Product / Process Change Notification (PCN)		
<input checked="" type="checkbox"/> Major change <input type="checkbox"/> Minor change		
PCN #: PCN_ConBHD_20220901 Affected Series: WE-ConBHD-6123xx20621 PCN Date: June 01, 2022 Effective Date: September 01, 2022	Change Category: <input checked="" type="checkbox"/> Equipment / Location <input type="checkbox"/> General Data <input type="checkbox"/> Material <input type="checkbox"/> Process <input checked="" type="checkbox"/> Product Design <input checked="" type="checkbox"/> Shipping / Packaging <input type="checkbox"/> Supplier <input type="checkbox"/> Software	
Contact: Product Management Phone: +49 (0) 7942 - 945 5001 Fax: +49 (0) 7942 - 945 5179 E-Mail: pcn.eican@we-online.com	Data Sheet Change: <input checked="" type="checkbox"/> Yes <input type="checkbox"/> No Attachment: <input type="checkbox"/> Yes <input checked="" type="checkbox"/> No	
Description and purpose of change: <p>Due to an improvement of the production capability, Würth Elektronik will change the production location and production equipment. Plastic housing design, PCB layout and quantity of product per reel and per carton will also change. Additionally the WE logo w

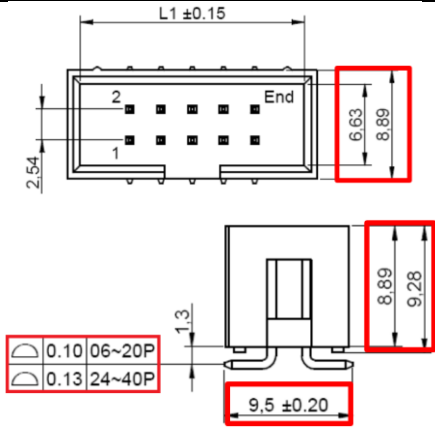
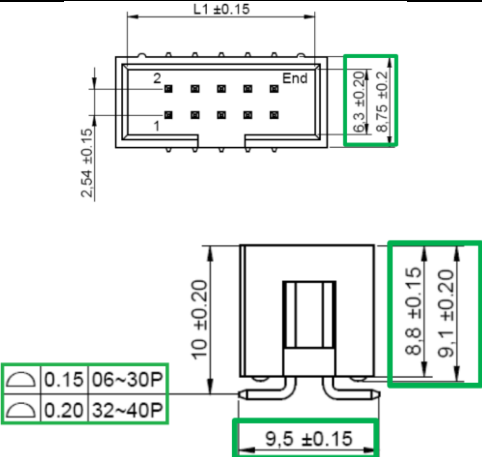
Detail of Change:		
CHANGE	6123XX20621	
	BEFORE CHANGE	AFTER CHANGE
HOUSING AND TERMINAL DESIGN OPTIMIZATION (DIMENSIONS AND TOLERANCING)

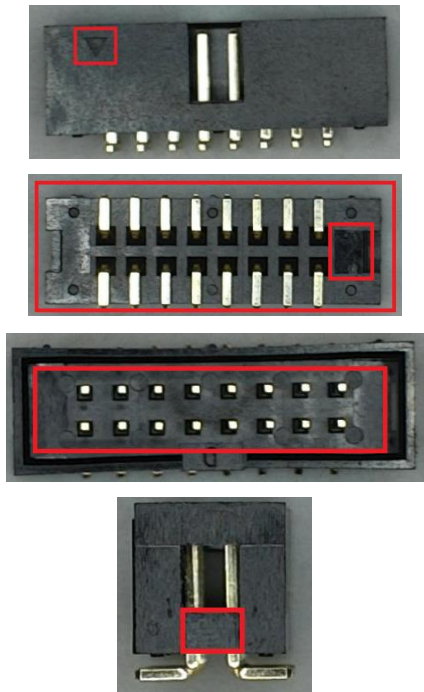
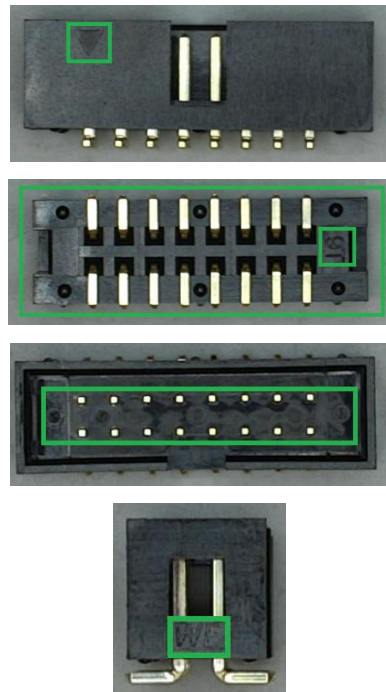
<p>VISUAL APPEARANCE (FIRST PIN ARROW, PART DETAIL, WE LOGO)</p>		
<p>LAYOUT MODIFICATION</p>
